**Addendum #1 to:
Application for an
Environmental Act Licence for
an Additional Secondary Cell
to the Existing Adam Lake
Campground Wastewater
Treatment Lagoon in Turtle
Mountain Provincial Park**

Project No. 111217030

June 9, 2016

Addendum #1 is submitted to clarify, and provide additional information, with respect to the questions asked in the April 29, 2016, letter; and May 27, 2016 email, from Barsha Sagan, P.Eng., of Environmental Approvals Branch, Manitoba Conservation and Water Stewardship.

EXISTING/PROPOSED TREATED
EFFLUENT DRAINAGE ROUTE
ADDENDUM NO. 1

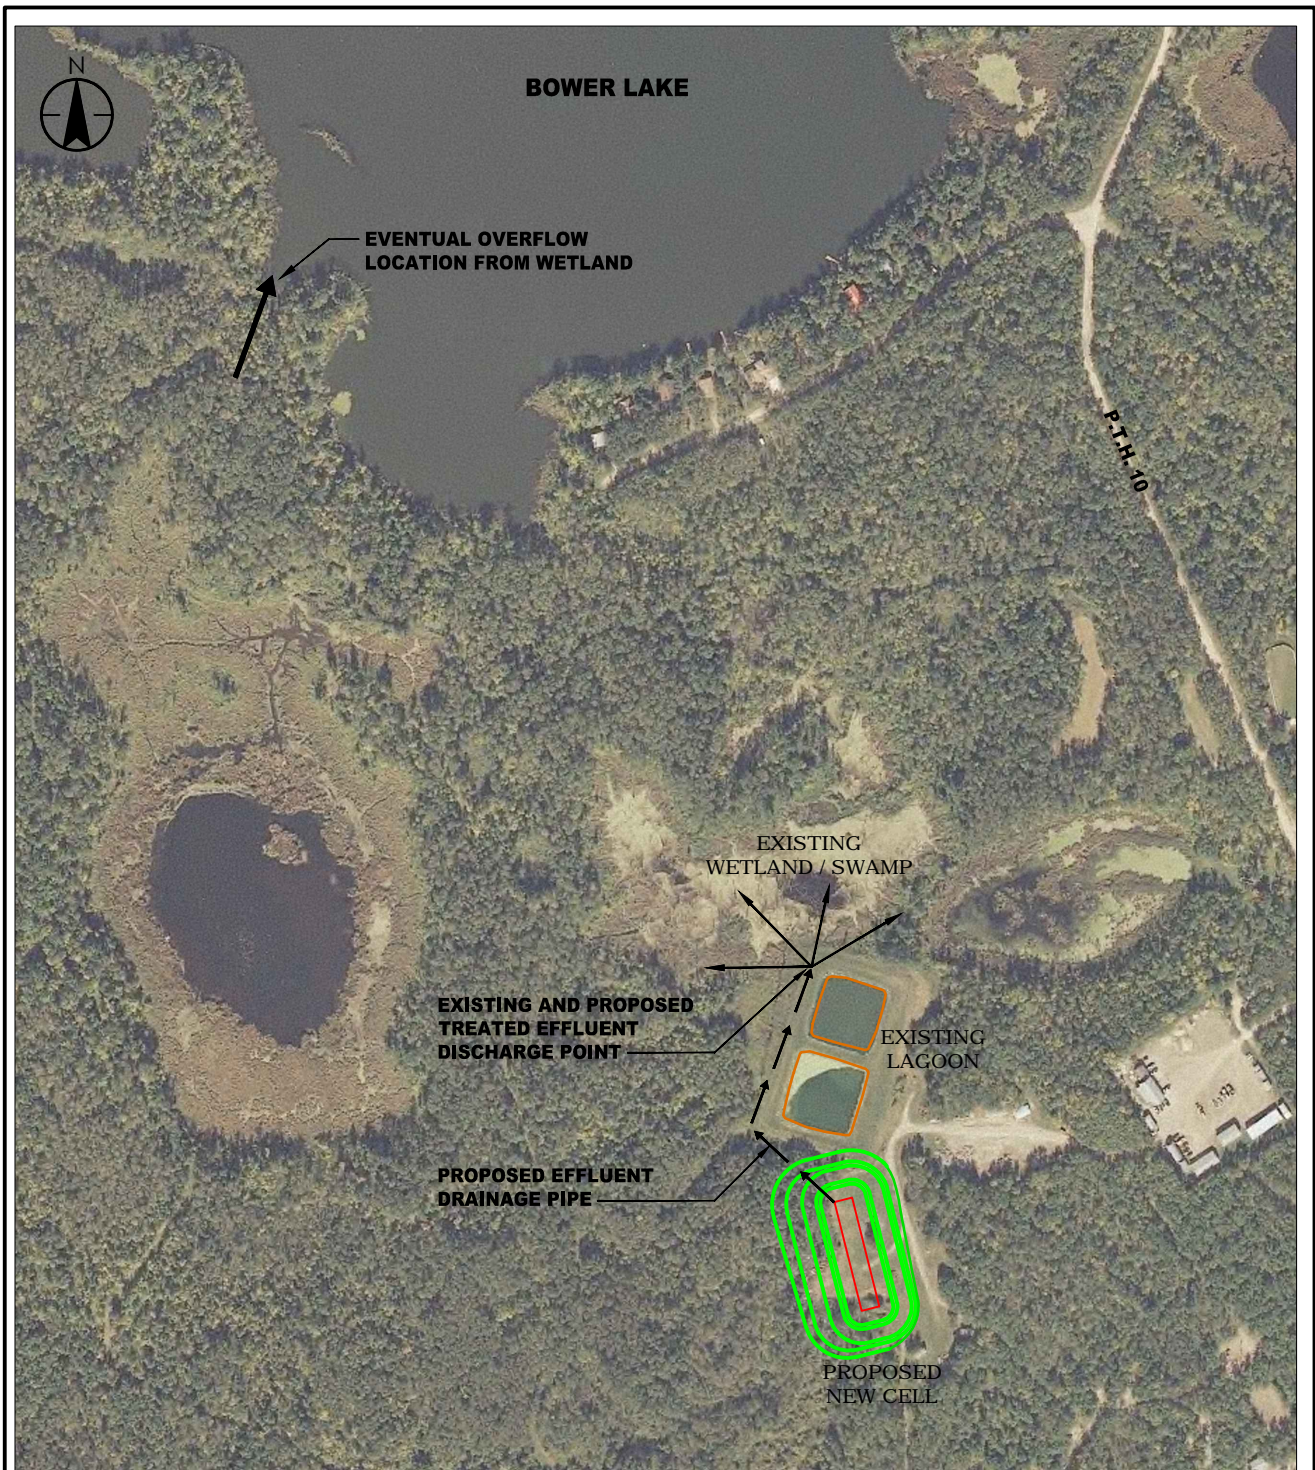
1. Please clearly identify the drainage route from the lagoon discharge location to the final receiving stream which is Bower Lake.
2. Please provide engineering drawings of the proposed lagoon design indicating the following items:
 - legal address/description, project region and location plan of the lagoon;
 - sizing of the lagoon cells;

a) The treated effluent drainage route is shown on attached Figure No.1.0. There is no ditch or drain in the receiving wetland. The discharged treated effluent goes to this approximately 20 hectare large wetland and is absorbed. When the wetland as a whole reaches a high enough water level, it would overflow into Bower Lake at the location shown on the Figure. This is the discharge method for the existing lagoon and we understand there have been no concerns in the past.

SITE PLAN AND DETAILS
 ADDENDUM NO. 1

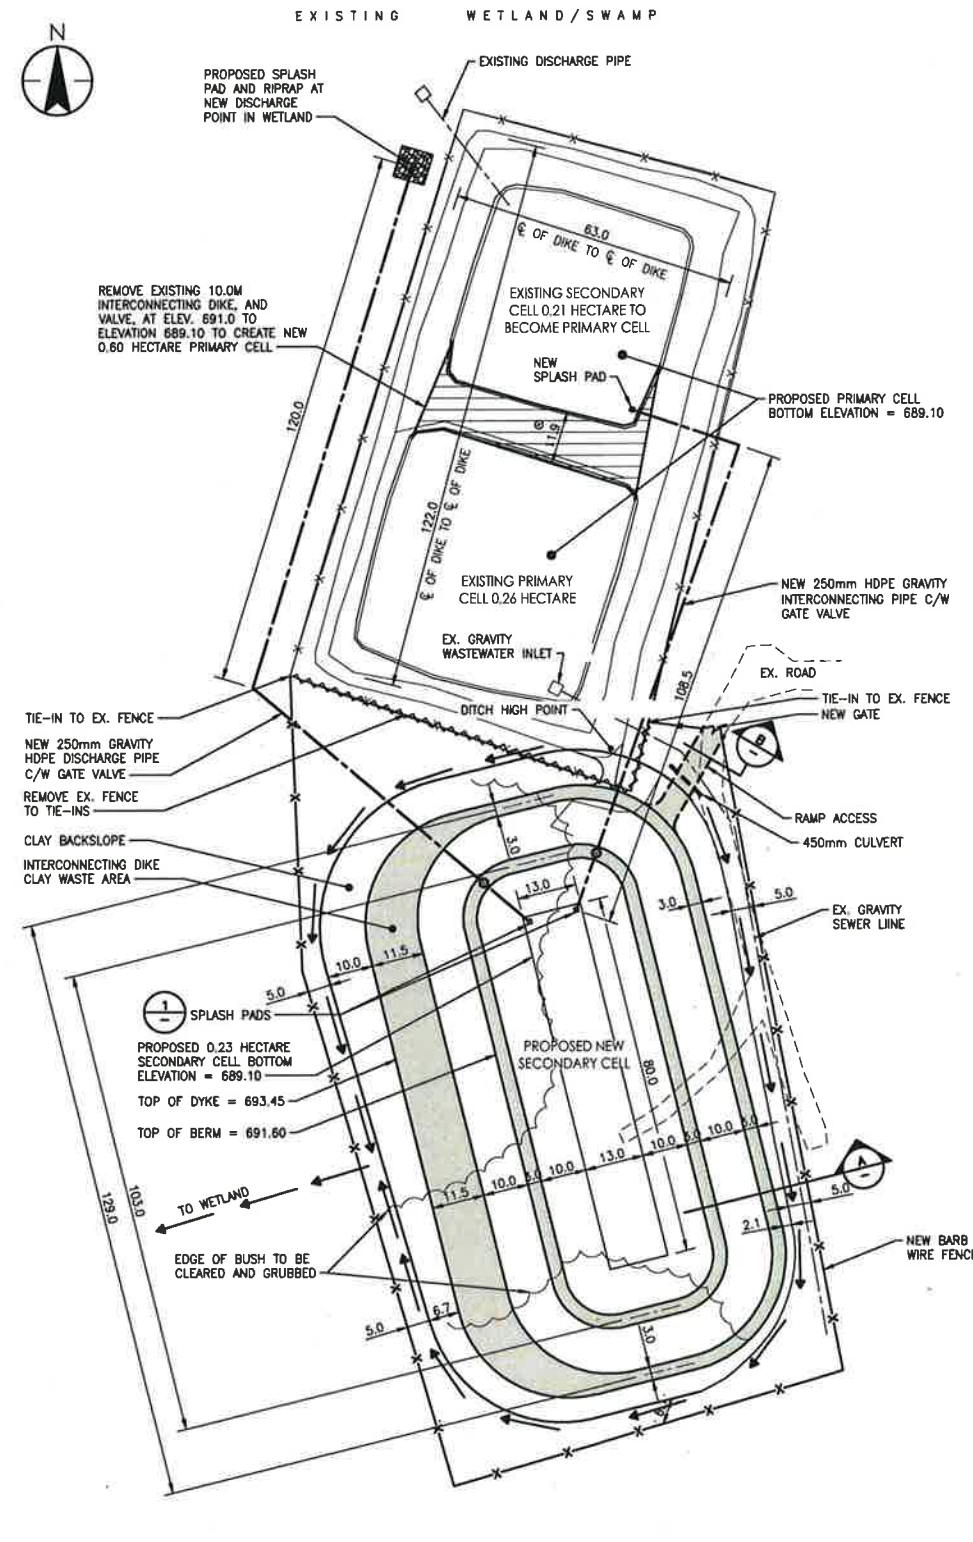
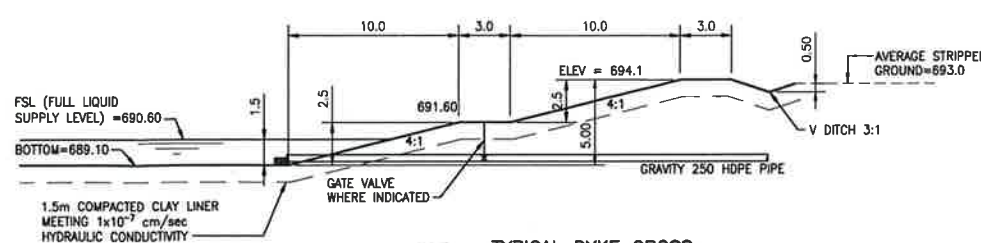
- lagoon cross sections;
 - cross section of lagoon liner and clearly displaying the location of the minimum 1 meter thick continuous soil liner as well as whether or not the clay soil liner would be compacted as a specific component of construction;
 - entire drainage route from the lagoon discharge outlet to the final receiving stream.
3. Please include more details on how and where the materials from the existing dike would be disposed.

4. Is there any plan of constructing a perimeter ditch around the proposed secondary cell? The dyke cross section indicates that the land on the east side of the proposed lagoon is off higher elevation side and a proposed perimeter ditch would be constructed on that side. Where will the planned perimeter ditch drain to? Is it possible to provide more information on that item?

5. Please provide the dimensions of the altered primary cell.
6. Show location and provide characteristics of fence and gate(s).

a) The legal description and location plan are shown on Drawing C-101. Figure No. 2.0 shows the aerial view of the sections of land in the general area.

b, c and d) The engineering design is shown on attached Drawing No. C-101. The drawing details the lagoon plan and cell sizes, dimensions, typical cross section, access ramp for vehicles, clearing and grubbing limits, treated effluent drainage route, legal description of site, compacted clay liner, clay disposal site, perimeter ditching on all sides, notes, and related data.

The interconnecting dike clay disposal site is shown on Drawing No. C-101. The existing interconnecting dike would have the organic top materials removed and then the approximately 1500 m³ of clay would be disposed of on the west side (wetland side) of the new cell. This disposal site would be cleared and grubbed, stripped to clay, compacted, and clay would be deposited in compacted maximum 300 mm lifts. The clay disposal site will be approximately 2 m in thickness x 100 m x 7.5 m and upon completion 3:1 sideslopes will be constructed. The entire clay disposal site will be covered with 100 mm of select site organic material, and seeded. The new lagoon cell is designed to have a cut/fill balance.
